# UNITED STATES PATENT AND TRADEMARK OFFICE

APPLICATION NO.	FILING DATE	FIRST NAMED INVENTOR	ATTORNEY DOCKET NO.	CONFIRMATION NO.
10/663,918	09/16/2003	Richard A. Wilsak	37,512	2288
7590	03/25/2010		EXAMINER	
BP America Inc. Docket Clerk, BP Legal, M.C. 5East 4101 Winfield Road Warrenville, IL 60555			POPOVICS, ROBERT J	
		ART UNIT	PAPER NUMBER	
		1797		
			MAIL DATE	DELIVERY MODE
			03/25/2010	PAPER

<b>Office Action Summary</b>	<b>Application No.</b>	<b>Applicant(s)</b>	
	10/663,918	WILSAK ET AL.	
	<b>Examiner</b>	<b>Art Unit</b>	
	/Robert James Popovics/	1797

### DETAILED ACTION

Figure 1 Annotated in View of The Example

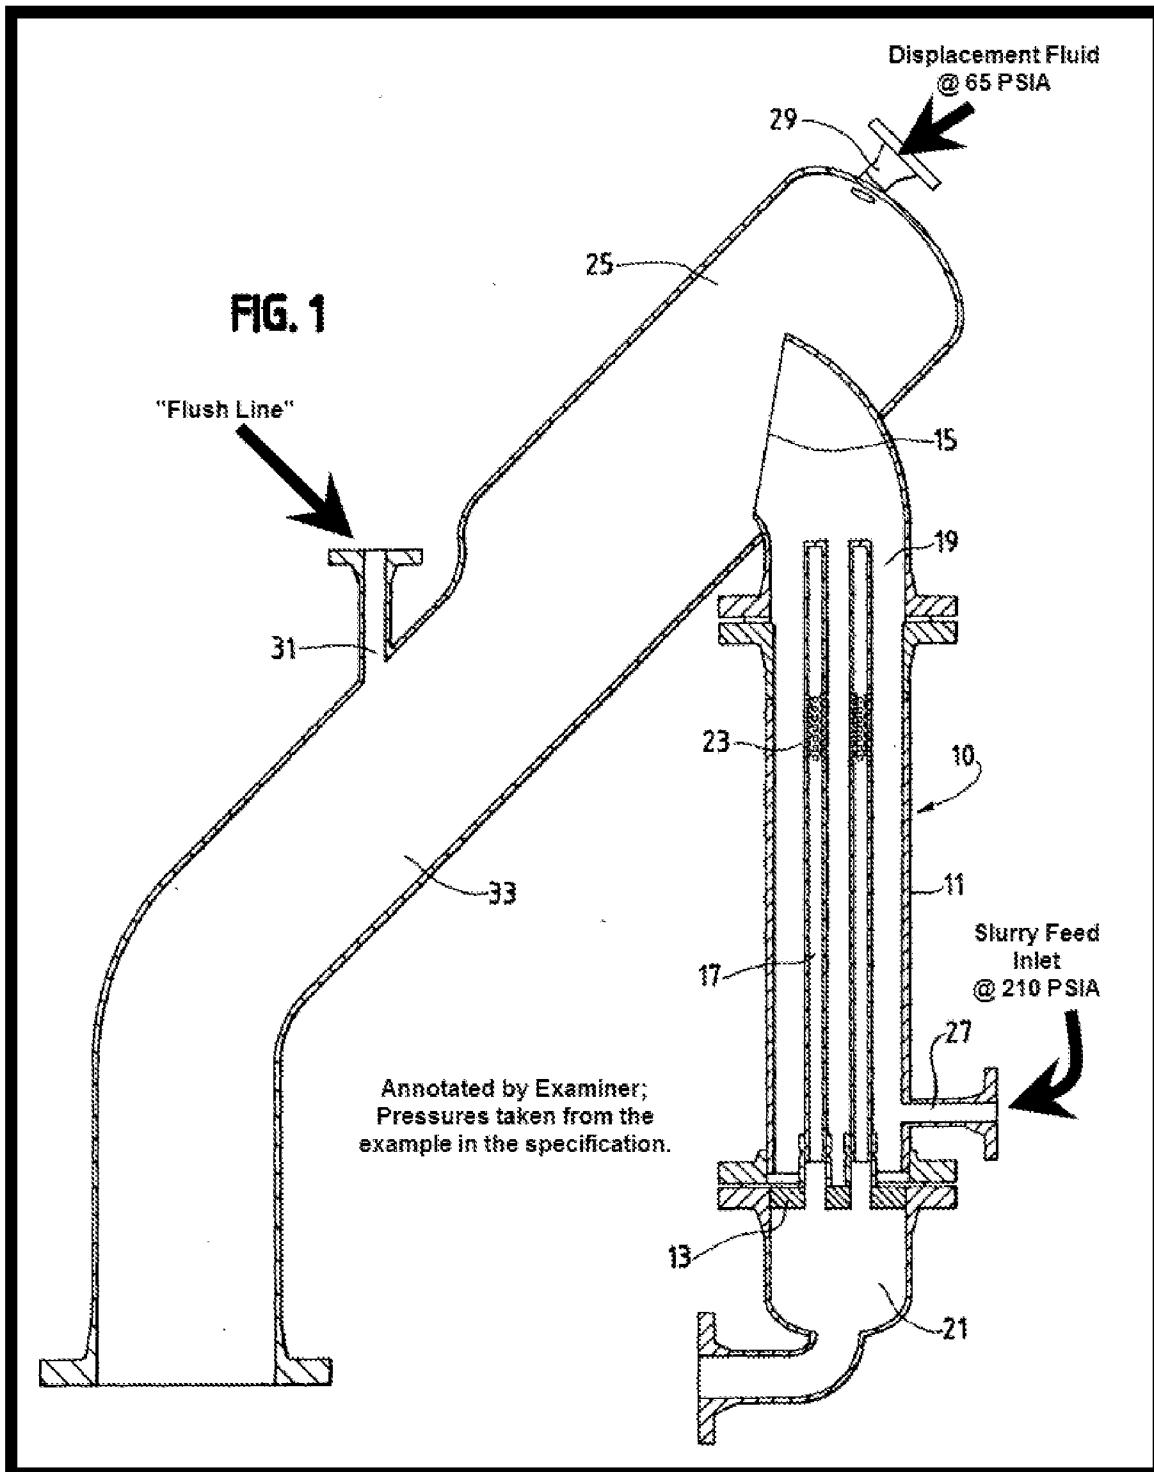
In this regard, it is noted that the only apparatus disclosed to accomplish this step is Fig. 1, which discloses an open chute 33. As such, it is unclear how the above stated step would be accomplished. It is axiomatic that a fluid under pressure will follow the path of least resistance. Referring to Fig. 1, that would be chute 33.

After considering the pressures set forth in the sole example, it is unclear how any displacement fluid at 65 PSIA will simultaneously flow down filter column 10, when slurry at 210 PSIA is being introduced thereto via slurry feed inlet 27. Previously, Applicants trivialized the controls/valves necessary to practice the invention, citing to Hybritech. Unfortunately, the undersigned disagrees, considering those controls essential to the practice of the invention. Applicants' arguments, citing to the sole example, only serve to bring more questions to the surface. What would permit flow in a direction from a lower pressure (e.g., 65 PSIA) to a region of higher pressure (e.g., 210 PSIA)?

FIG. 1

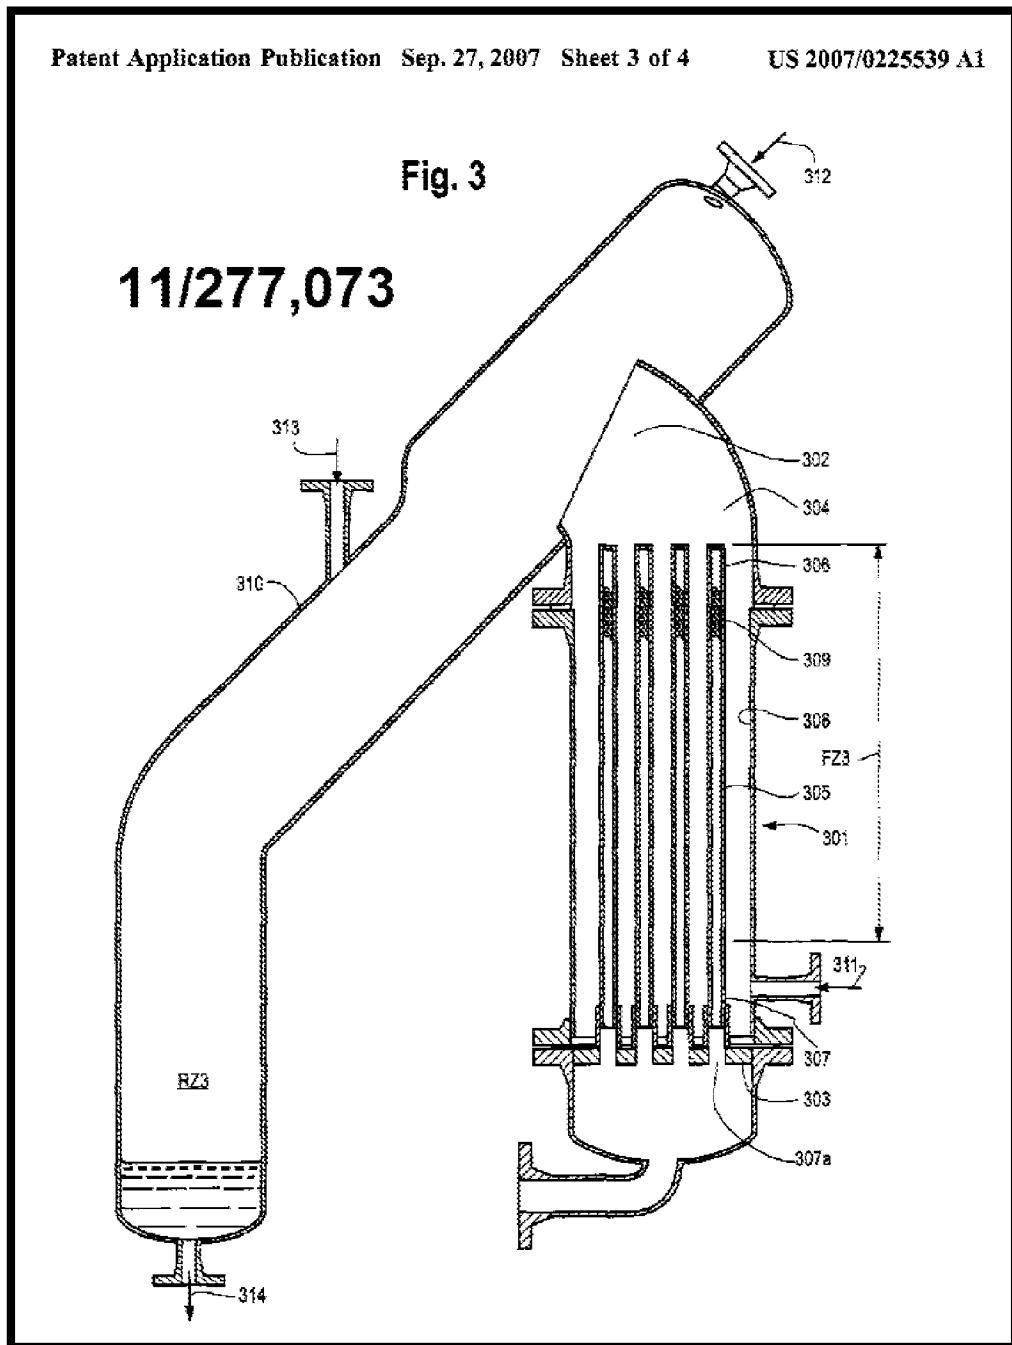
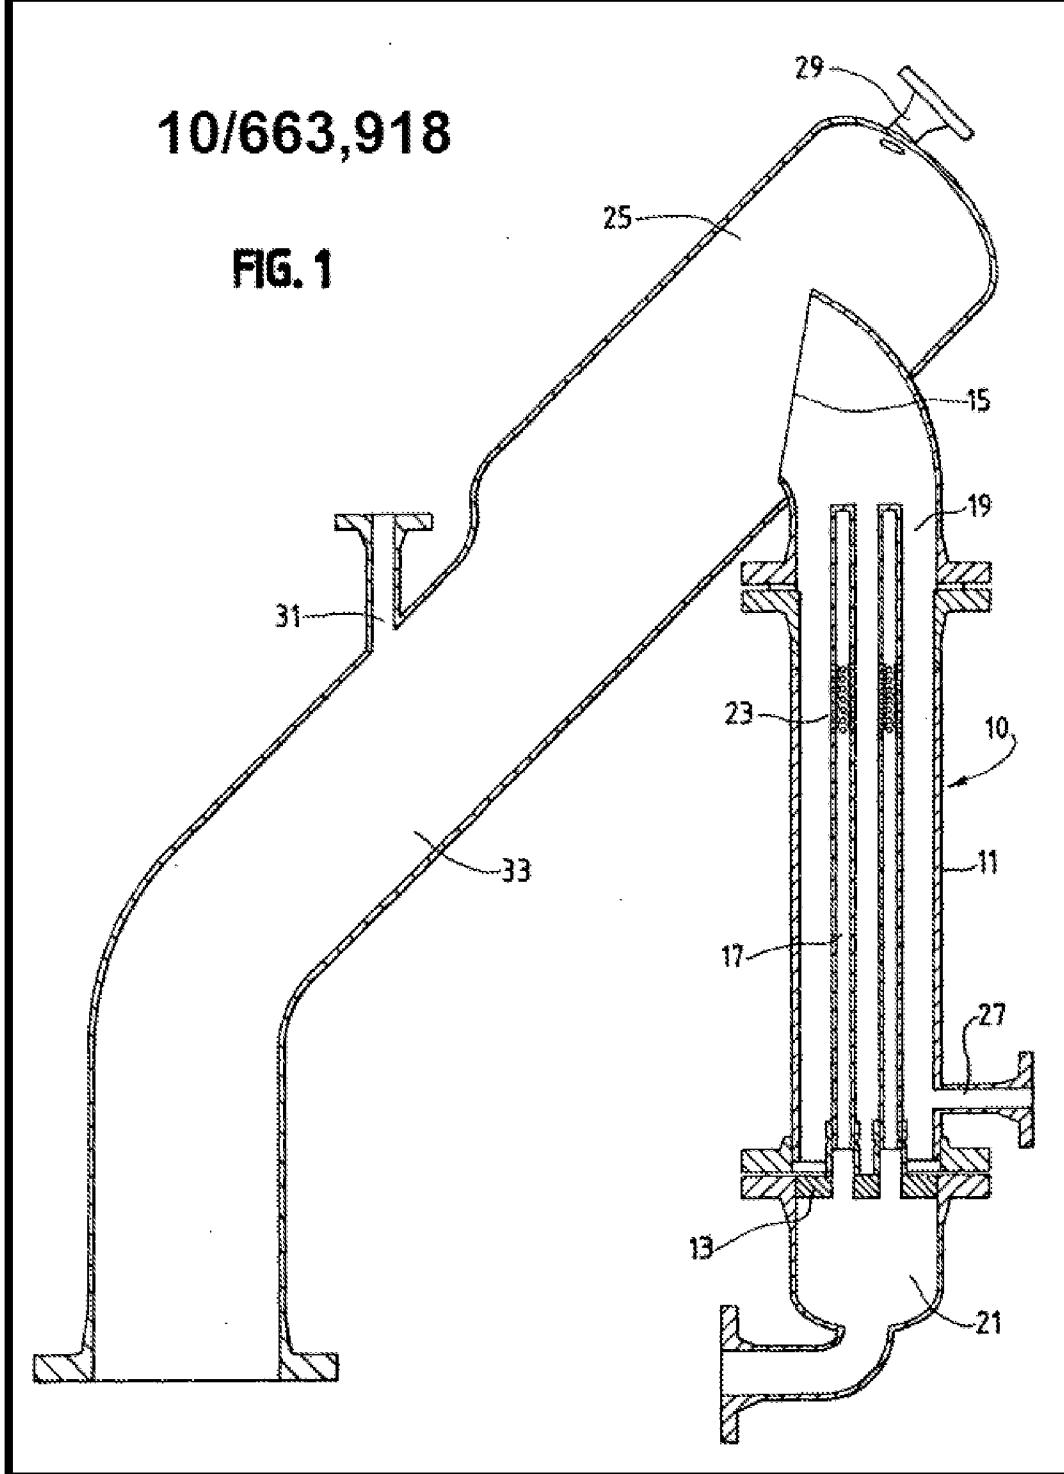
Claims **1,2,5-16,40,41,44,45,48 and 49** are rejected under 35 U.S.C. 112, first paragraph, because the **best mode** contemplated by the inventor has not been disclosed. Evidence of concealment of the best mode is based upon **Figure 3 of US 2007/0225539 A1**.

Comparing Figure 3 of US 2007/0225539 A1 with Fig. 1 of the instant disclosure

it would appear that something is missing. Specifically, there is no means disclosed for controlling the pressure at the open end of chute 33.
